FIELD SERVICE BULLETIN

FSB Number: LVCCFSB2006-14
 Authors: Darwin Garcia
 Date: February 22, 2006
 Total No. of Pages: 3
 Subject: **V3 & V3i Keypad Backlight Low Brightness**
 Model Affected: **V3, V3i**
 Level of Repair: 2

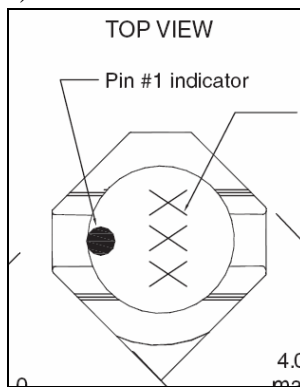
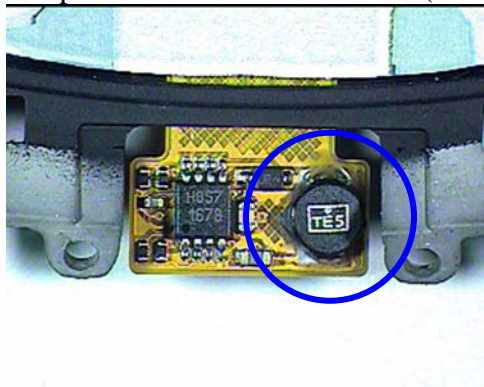
The root cause of the dimmer EL panel was the shorting of the core of the Coilcraft EL inductor to the soldered contacts causing a higher current drain.
 EL Inductor suppliers for V3 and V3i

Coilcraft EL Inductor (White)

Cooper Coiltronics EL Inductor (Black)

Solution

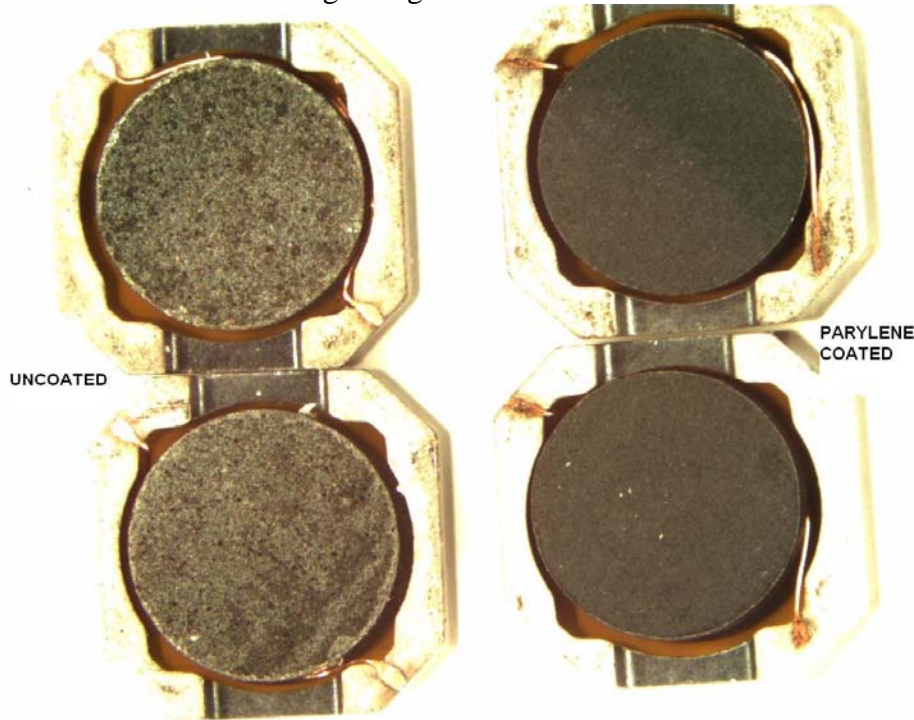
Coilcraft converted the EL inductor to a paralyne coating to prevent the shorting on November 9th as a running change.

When servicing any V3 and V3i customer phones with described issue, the K-Flex must be replaced. For V3 = 8489976N03 and for V3i = 8471183B02
